CHANGES AS SUBMITTED IN S4.55 -
UNDER REVIEW - MOD/2024/0225

1728 Fortis South Steyne

34-35 South Steyne Manly NSW

3 Ground 1:200

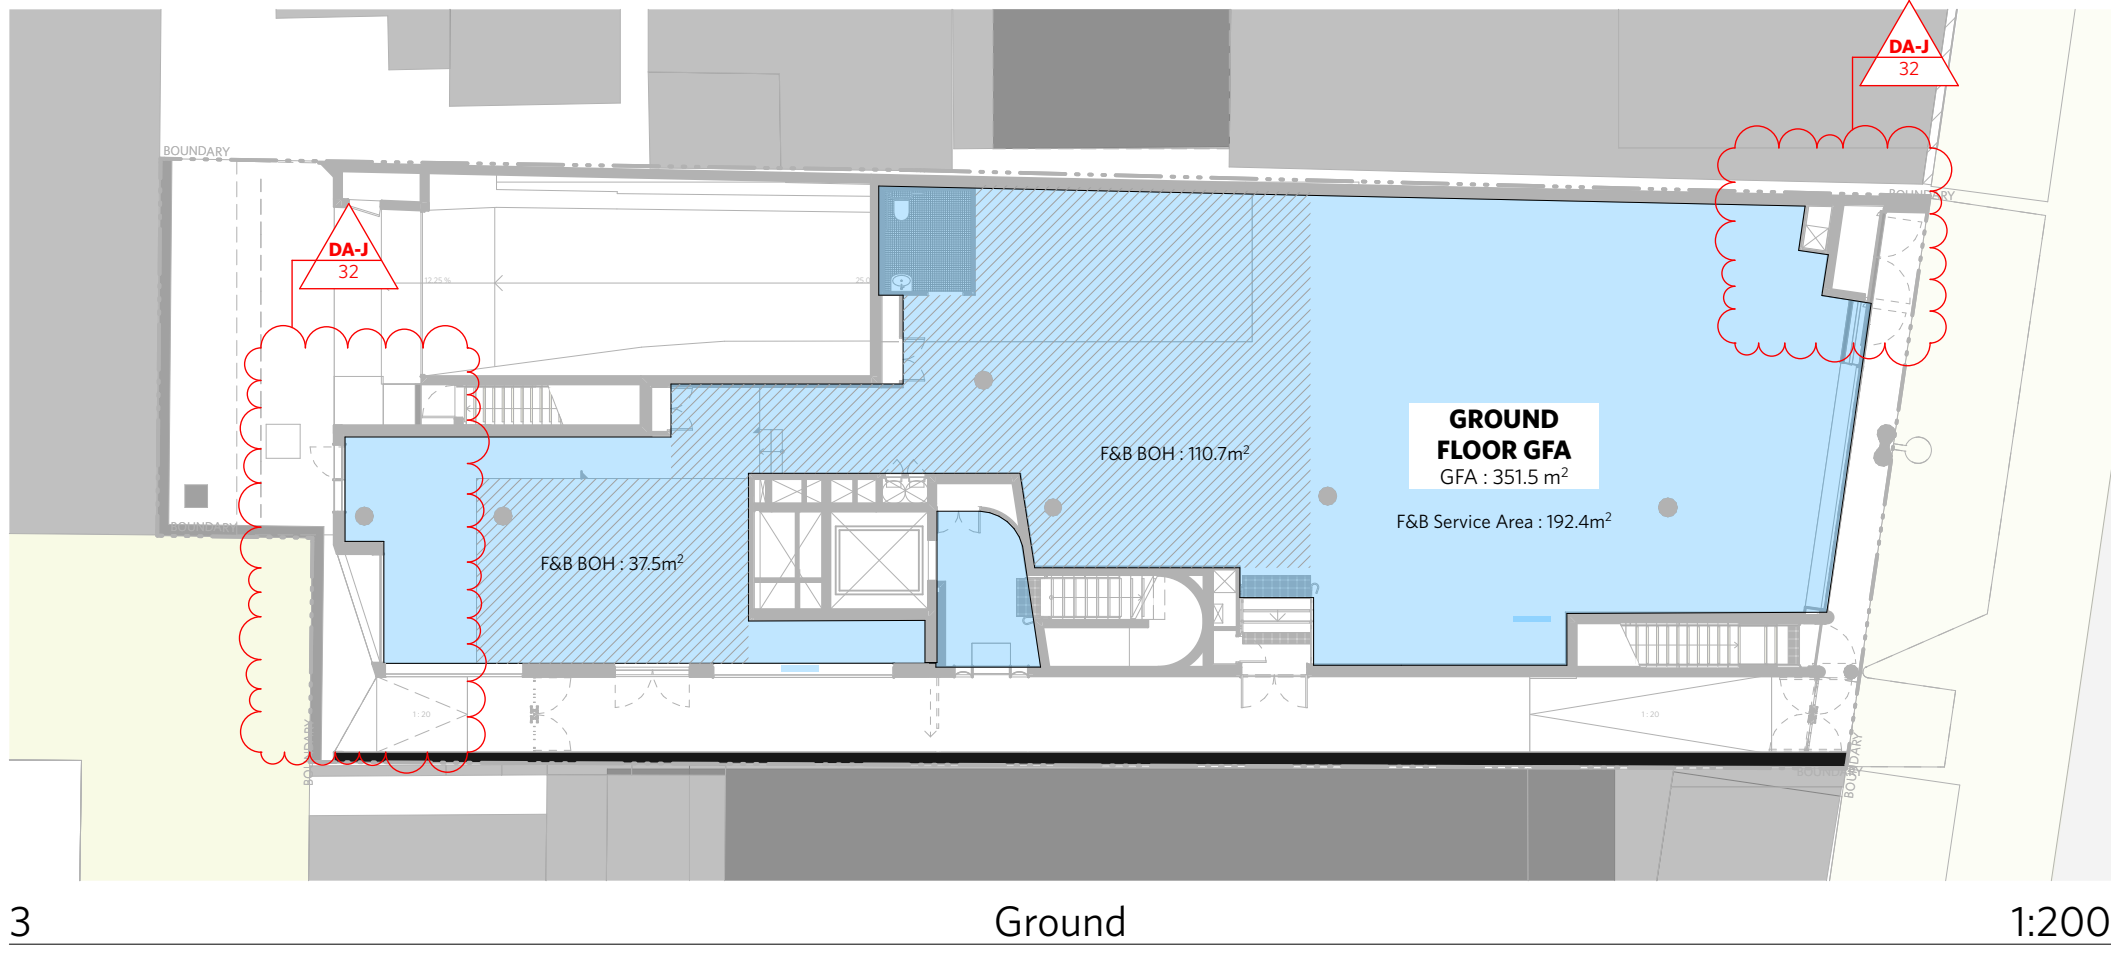
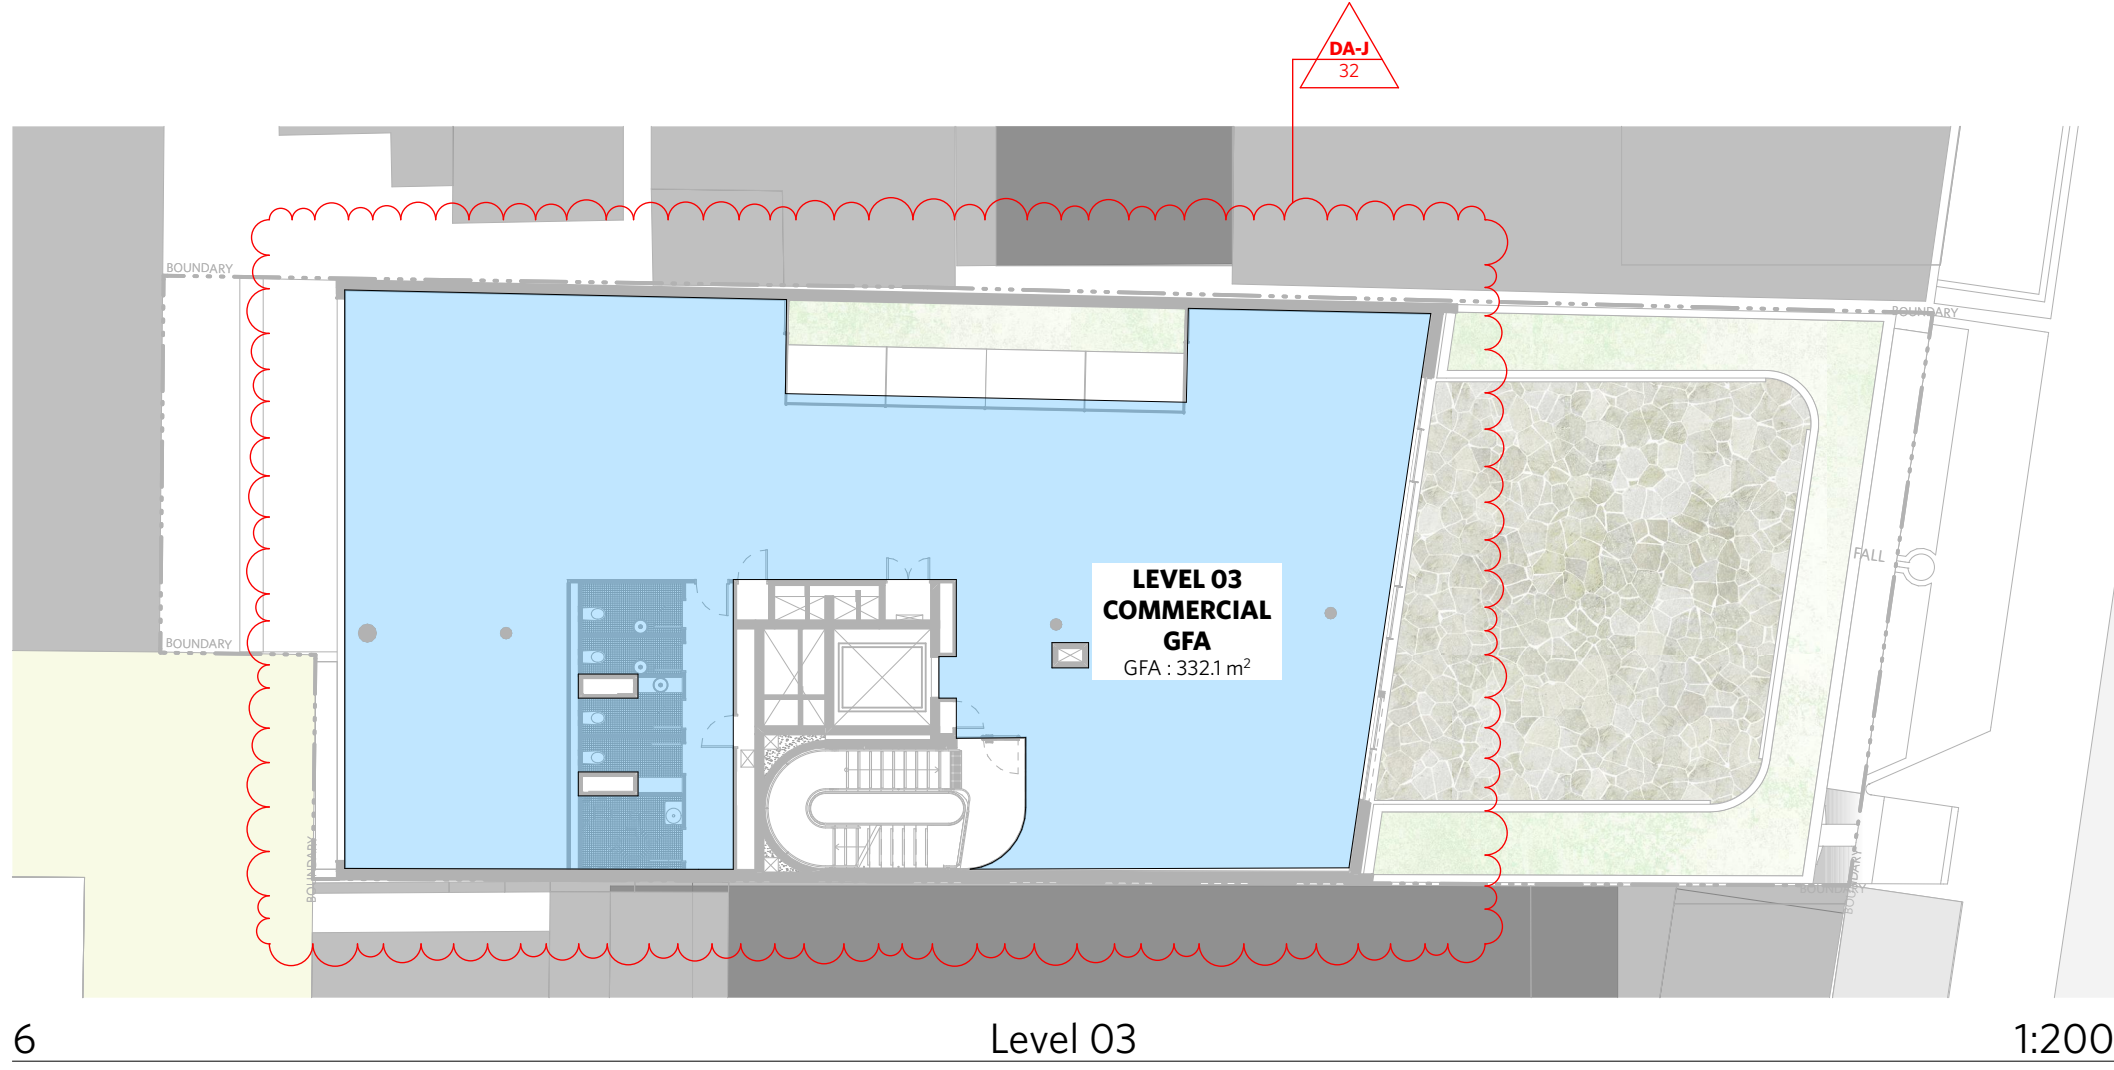
CHANGE SUMMARY		
REV	CHANGE	DESCRIPTION
DA-J	27	Increase in Floor Space to the west
	32	GFA Adjustment due to changes
